**City of Poughkeepsie
Historic District and Landmarks Preservation Commission
Meeting Agenda**

**RE: Pelton Mount Carmel
36 North Clover Street
Revised Submission**

Re: Project: Pelton Mount Carmel
36 North Clover Street
Re: Revised design of proposed development for HDLPC Approval

DATE:
7/5/17

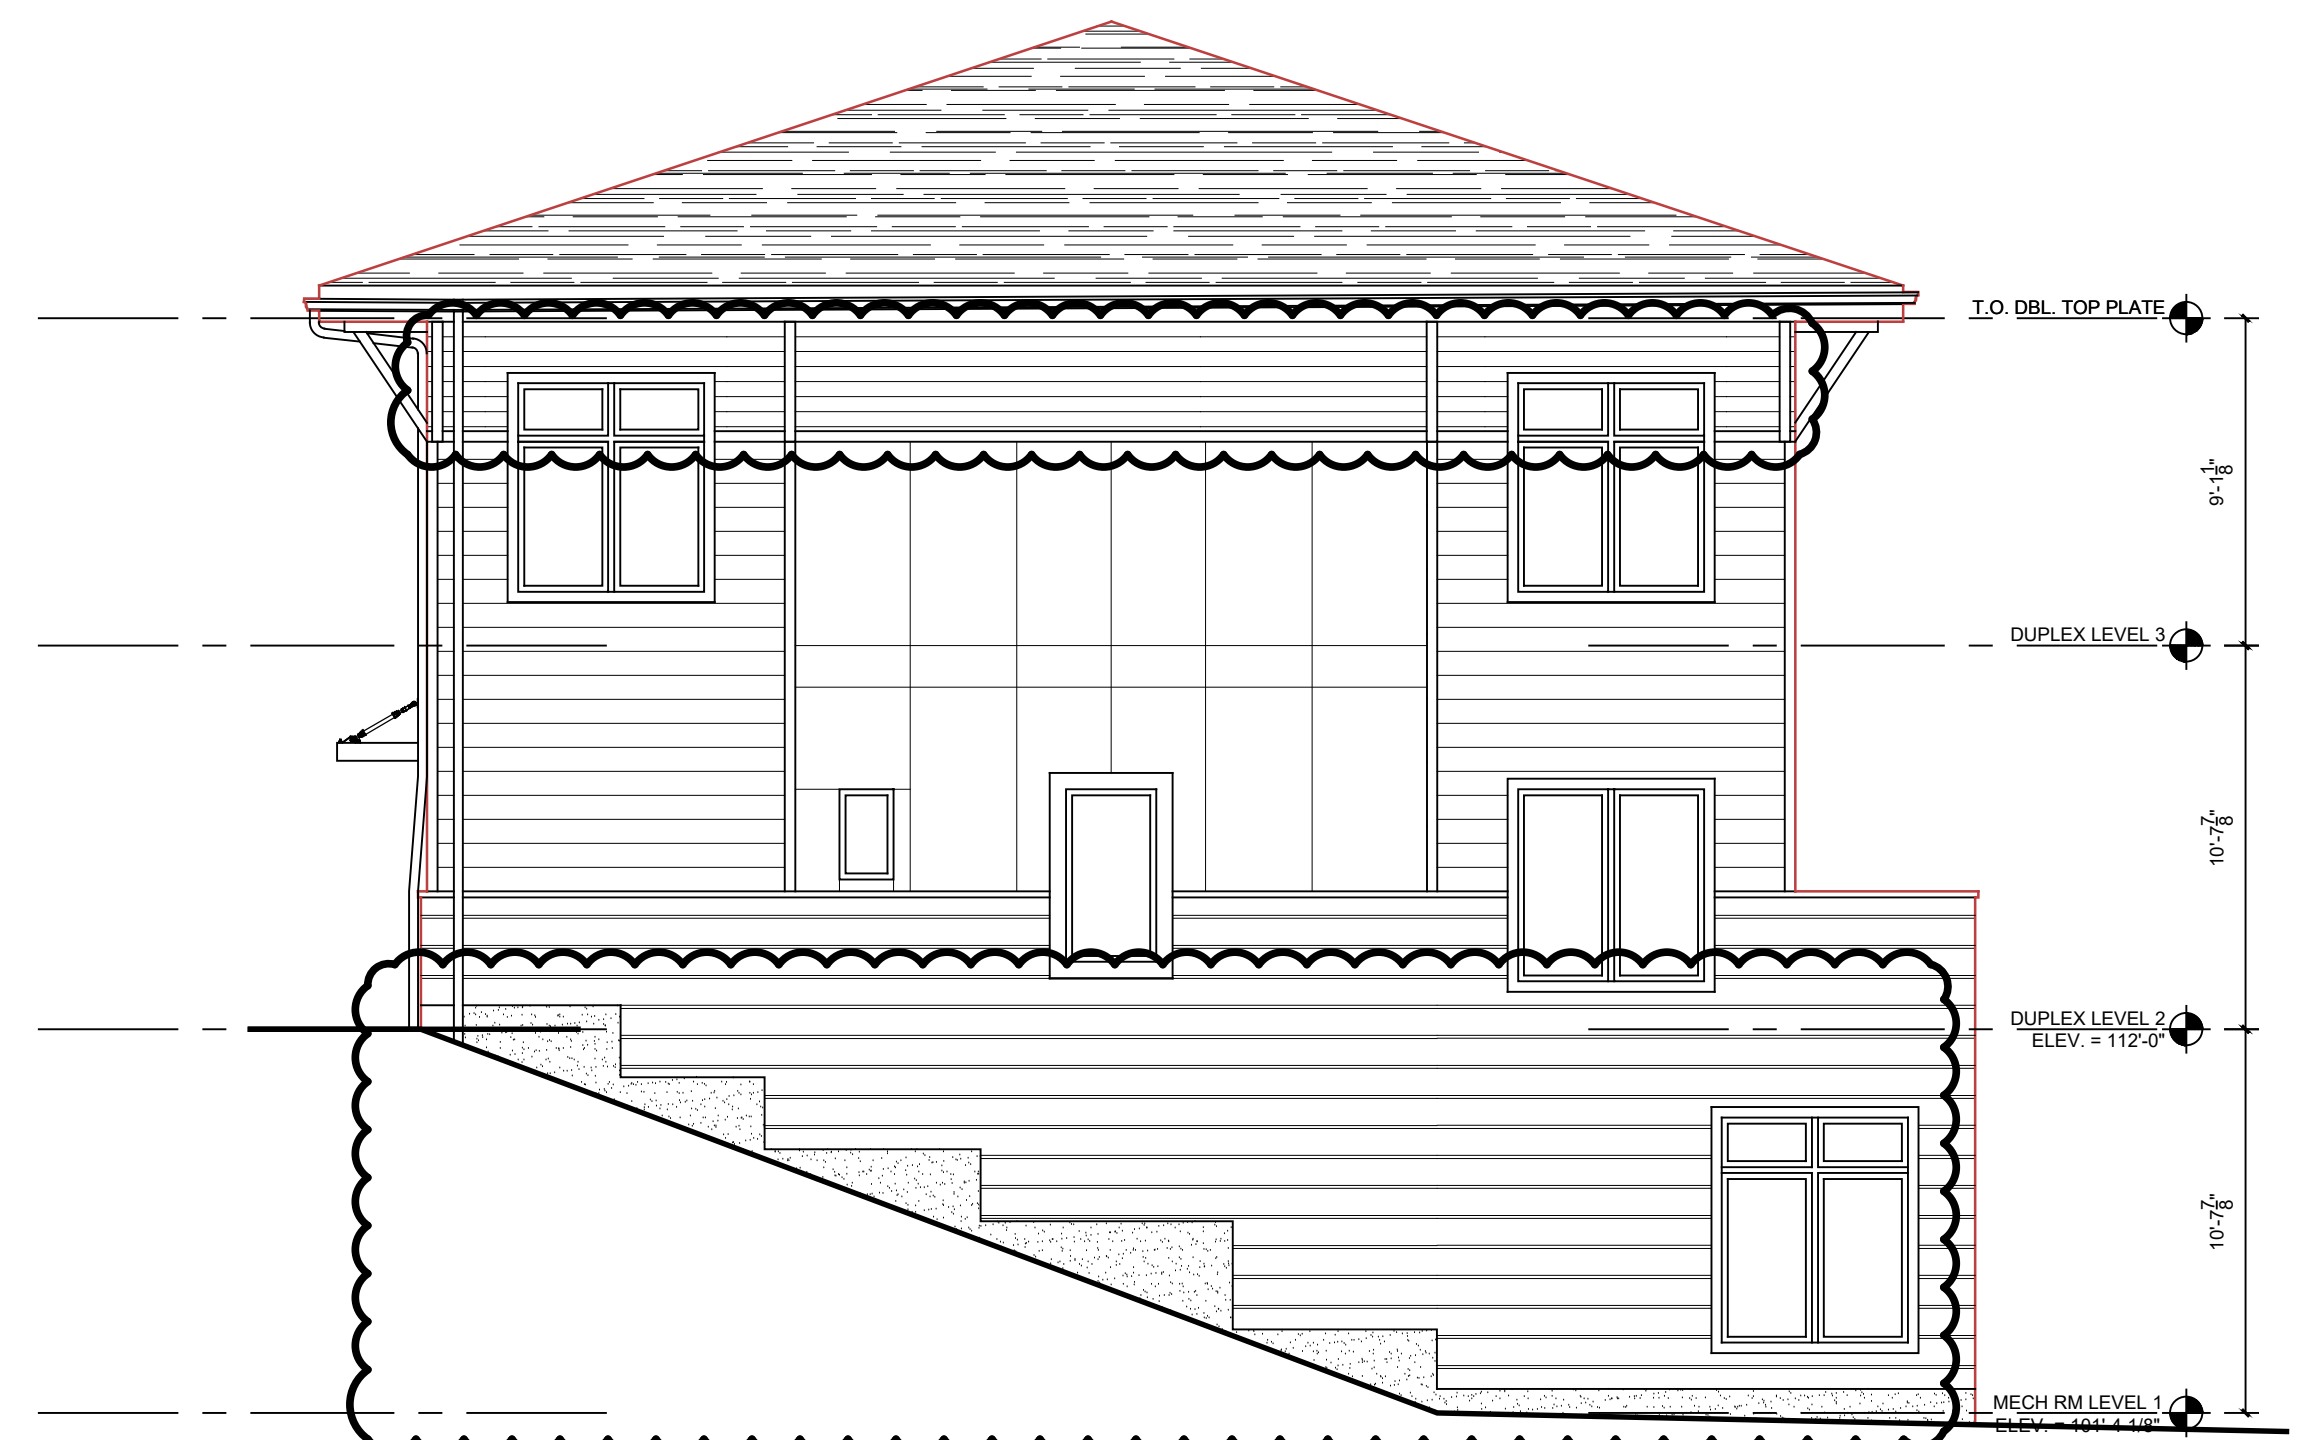
Sheet PZ-12 – Preliminary Elevations - Dongan:

1. On all elevations, the Upper Duplex Level 2 has been removed, thus lowering the height of the building.
2. The ridgeline of the roof has been lowered to a ridge height of 33'-9 3/8"
3. A "Tower" element has been created on the north and the south elevations of the building, reducing the width of this form. Refer to Elevations 1 & 4.
4. Elevation 2 – Dongan East Elevations
 - b. The Lower Duplex Level 1 has been modified to accommodate the proposed commercial space. This includes changes the elimination of a window for the former residential unit.
5. Elevation 4 – Dongan North Elevation
 - a. The Lower Duplex Level 1 has been modified to accommodate the proposed commercial space. This includes changes in the building materials and the window configuration in this area and the elimination of a door to the former residential unit.

1 STREET VIEW AT DONGAN PLACE
NTS

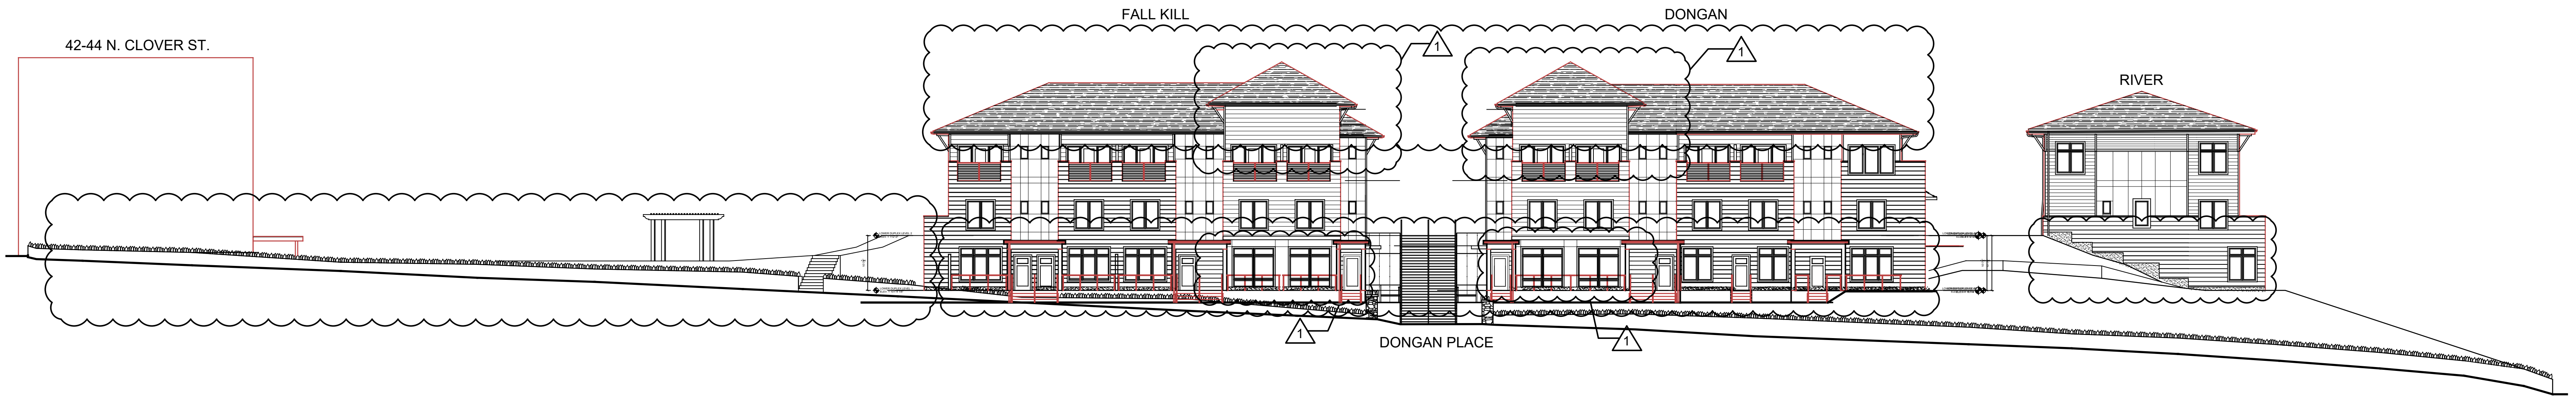
Sheet PZ-19 – Street Elevations:

1. Street View at Dongan Street
 - a. The changes that were outline for Sheet PZ-10 for the Fall Kill Building & PZ-12 for the Dongan Building have been incorporated into this street view.
2. Street View at Davies Place
 - a. The handicap ramp has been added to the Pelton Manor.
 - b. The elevation of the Dongan Building has been modified to reflect the reduction in the height of the building.

ENLARGED
MONUMENTAL STAIR
PLAN & ELEVATIONS

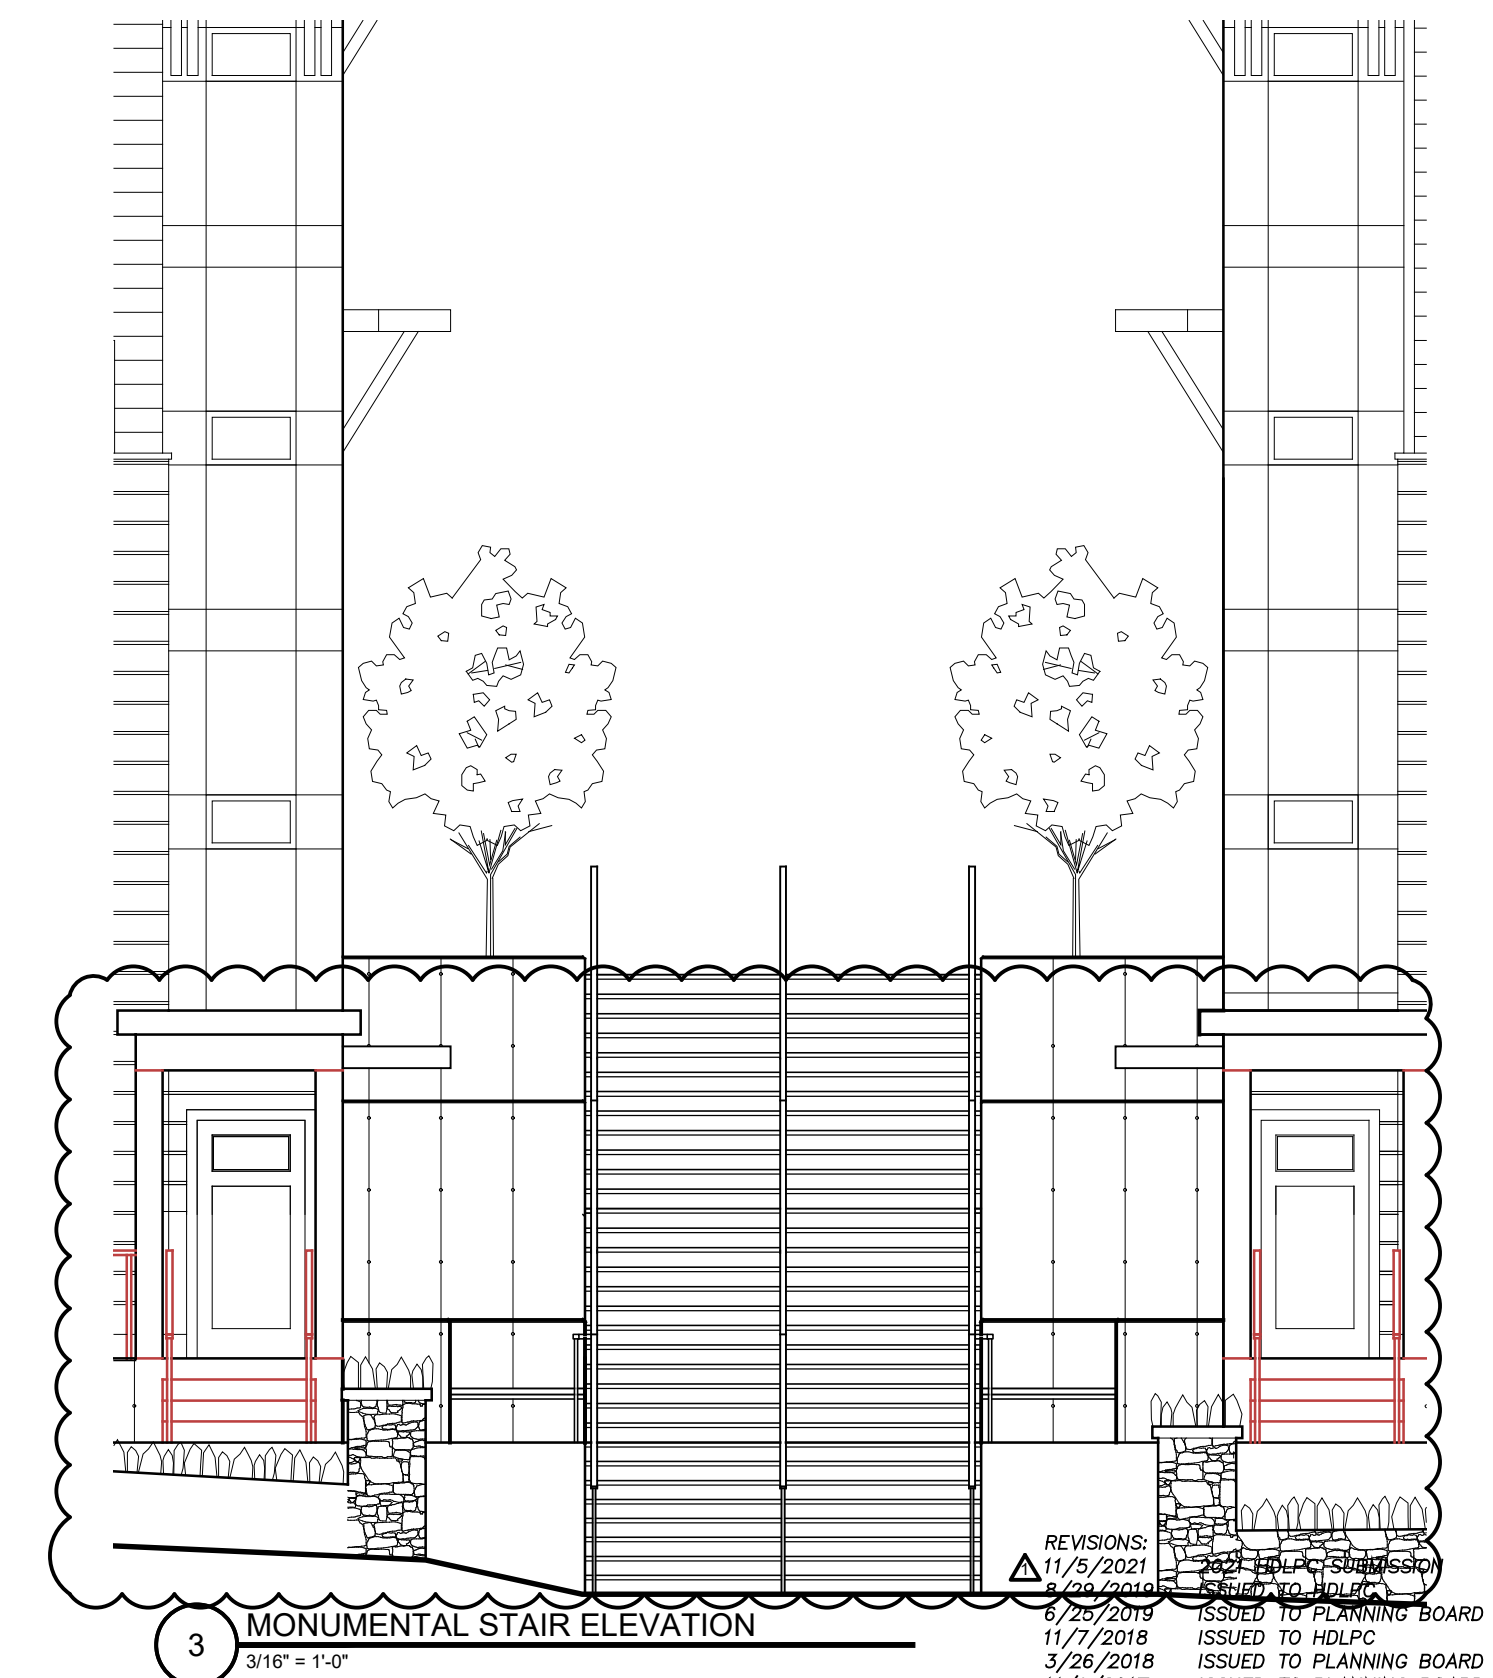
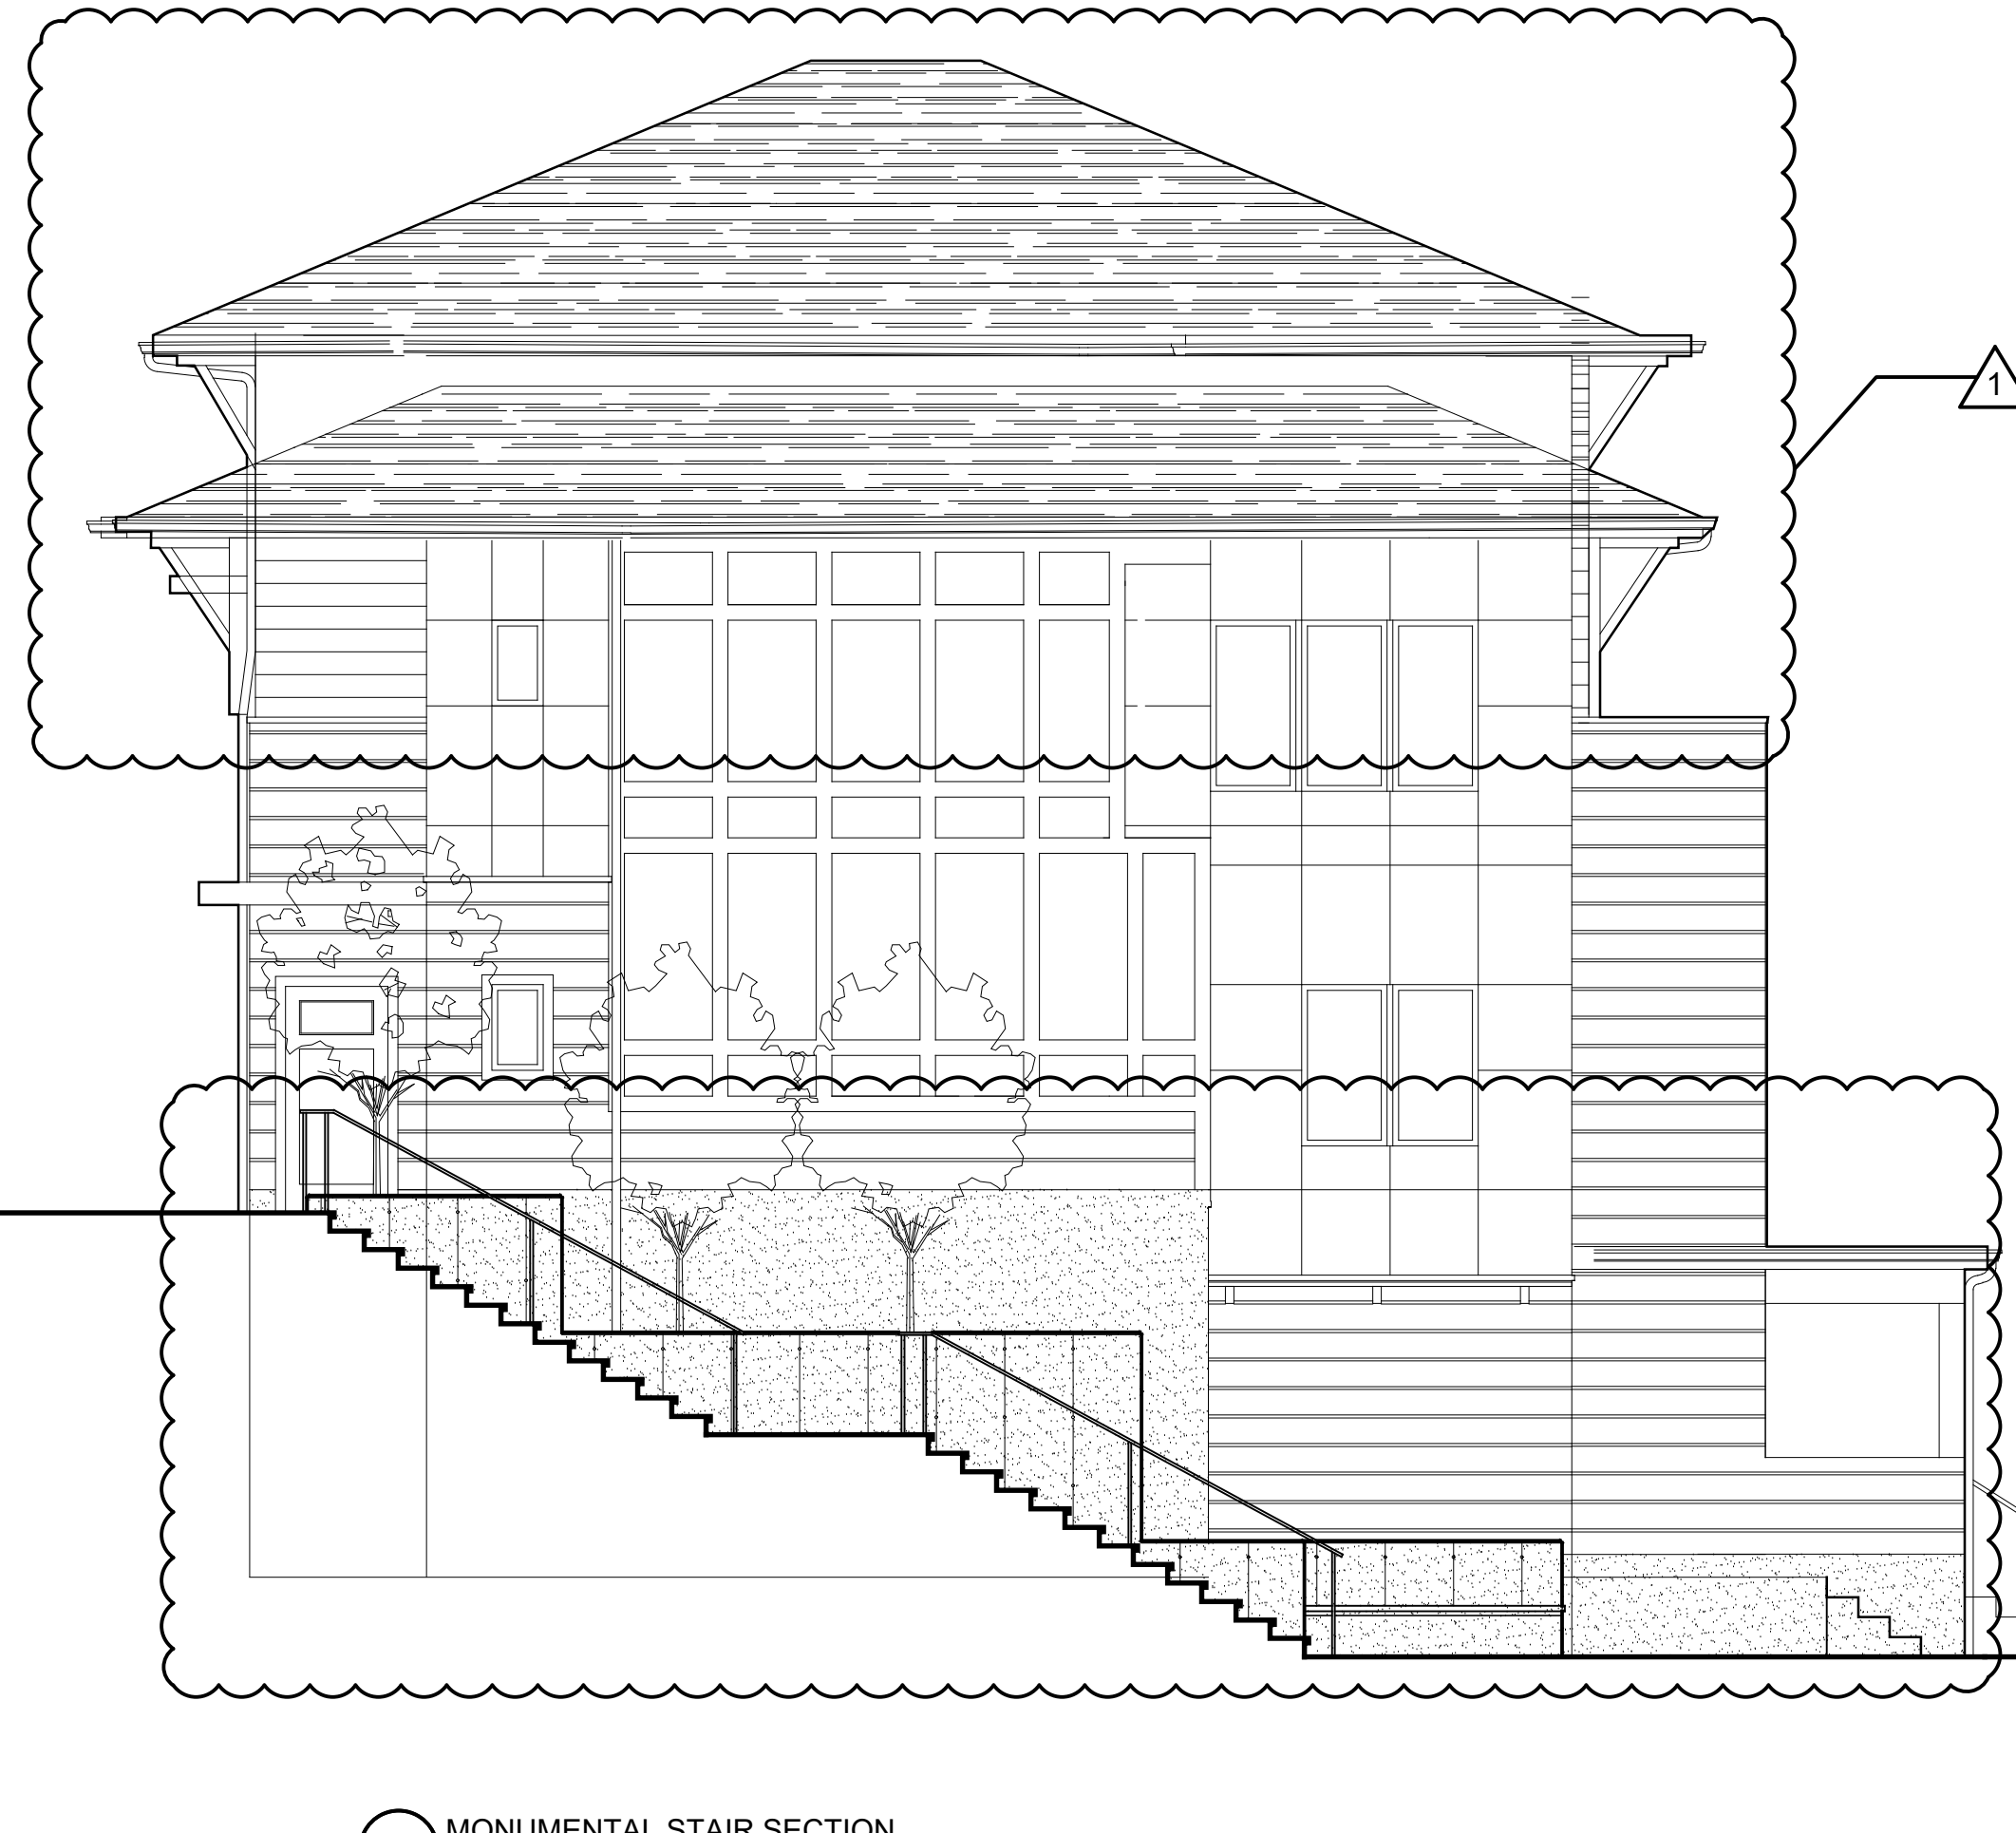
Sheet PZ-20 – Enlarged Monumental Stair Plan & Elevations:

2. Monumental Stair Section 2
 - a. The east elevation of the Dongan Building has been modified to reflect the reduction in height of the building, the new roof line as well as the elimination of the window on the Lower Duplex Level to accommodate the commercial use. Refer to Sheet PZ-12.
3. Building Section 4
 - a. The Upper Duplex Level 2 has been removed and the roof assembly has been lowered. Refer to Sheet PZ-12 for additional information.
